Subject: Duke Energy Carolinas, LLC
William States Lee III Nuclear Station - Docket Nos. 52-018 and 52-019
AP1000 Combined License Application for the
William States Lee III Nuclear Station Units 1 and 2
Response to Request for Additional Information
Ltr# WLG2010.10-09

Lee Nuclear Station Response to Request for Additional Information (RAI)

Reference NRC RAI Number: ER RAI 128, Alternatives

Figure 1 – Indirect Dry Cooling Towers in Series with Wet Cooling Towers

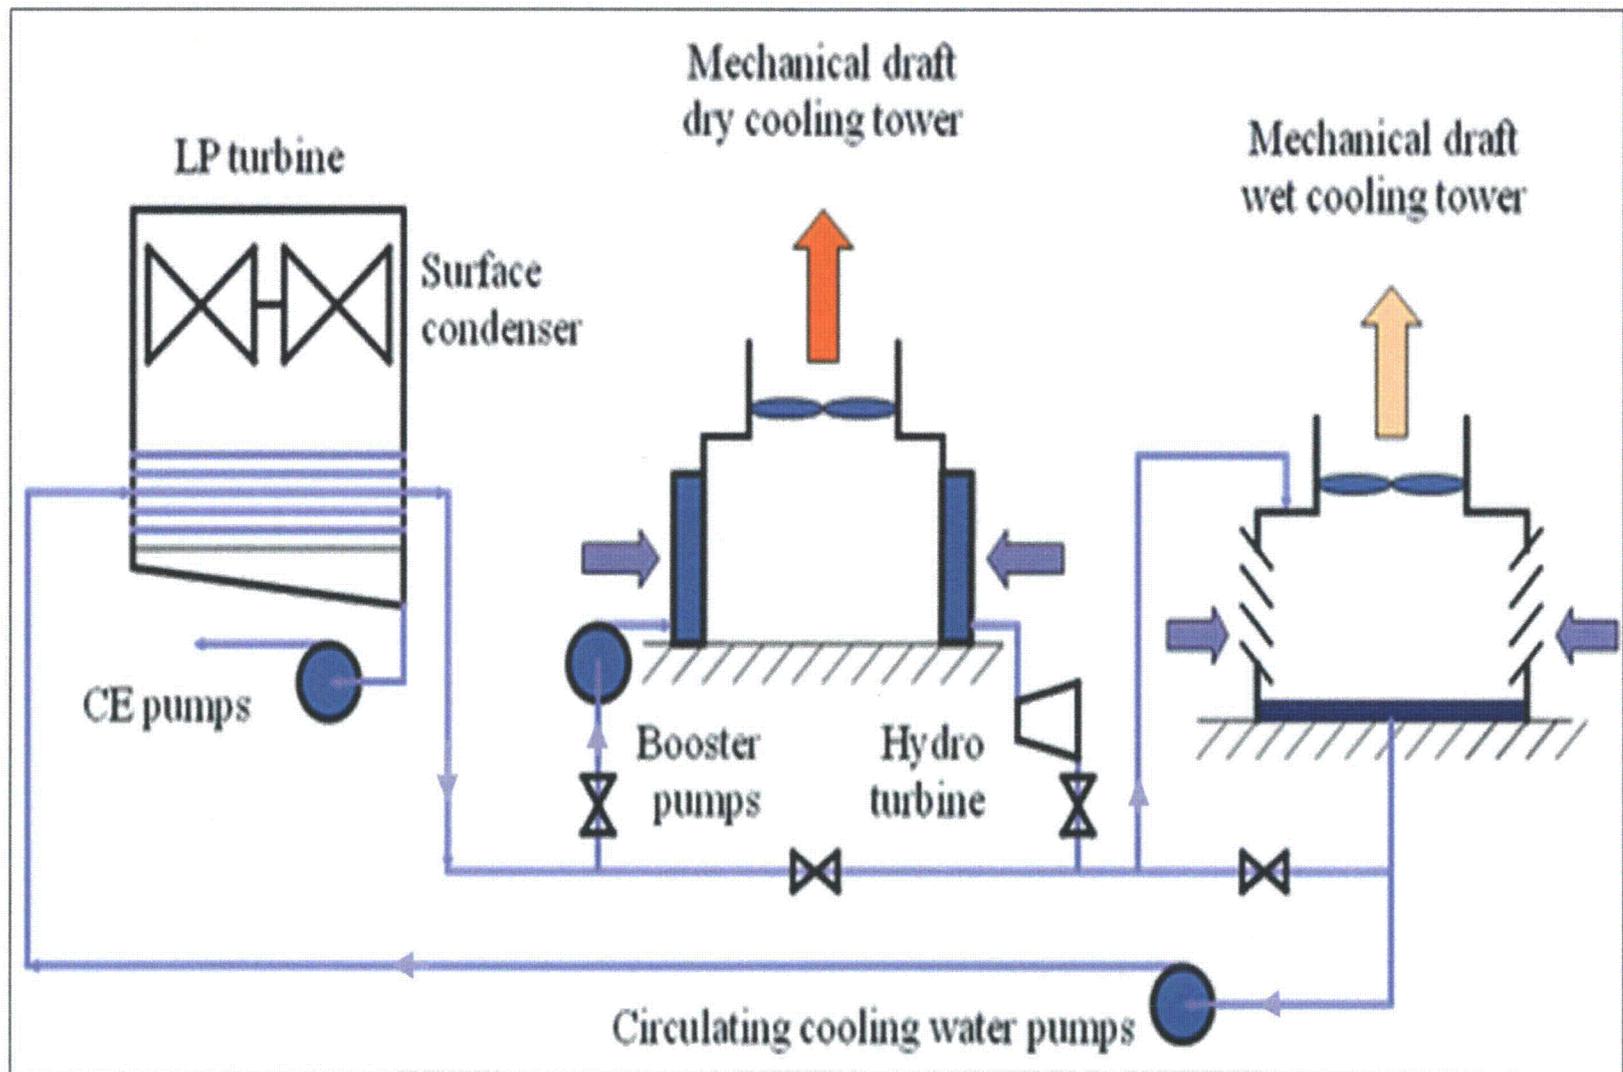
Provide details of the quantitative analyses used to evaluate hybrid wet-dry tower options for cooling of the proposed Lee Nuclear Plant during periods of low river flow. Include alternatives considered for cooling water sources and cooling system technologies. Include in the metrics of the analyses foregone net power due to parasitic energy losses, reduced generation efficiency, and frequency of outages due to loss of water supply.

The feasibility evaluation considered a hybrid cooling system comprised of 50% indirect dry cooling towers in series with 100% wet mechanical-draft cooling towers as shown in Figure 1 (Attachment 128-07). The dry cooling towers are assumed to be sized to reject 50% of the heat load at the design dry bulb temperature for the Lee Nuclear site of 92°F (1% exceedance). The wet cooling towers would be sized to reject 100% of the heat load. The dry cooling towers (3 per unit) would be very large (100 ft wide by 935 ft long by 100 ft high) owing to the significant surface area required for heat transfer to support the selected range of heat dissipation. A summary of the equipment footprint for the dry cooling towers is provided in Table 1 (Attachment 128-08). Land in the vicinity of the dry cooling towers would have to be cleared and maintained devoid of vegetation to avoid impacts to air flow and performance of the equipment.

The hybrid cooling system evaluated as an alternative heat dissipation system is comprised of 50% indirect dry cooling towers in series with 100% wet mechanical-draft cooling towers as shown in Figure 1 (Attachment 128-07). The dry cooling towers evaluated would be twice as large as any similar towers currently installed worldwide. Deployment of this hybrid cooling system would be “first of a kind” technology with uncertainties and questions about the system’s operational capability that would put a substantial generating and capital asset at risk of not performing adequately. Wet mechanical-draft cooling towers are in use at many operating power generation facilities in the United States and the world. Wet cooling towers are considered “existing technology” rather than “first of a kind” technology.
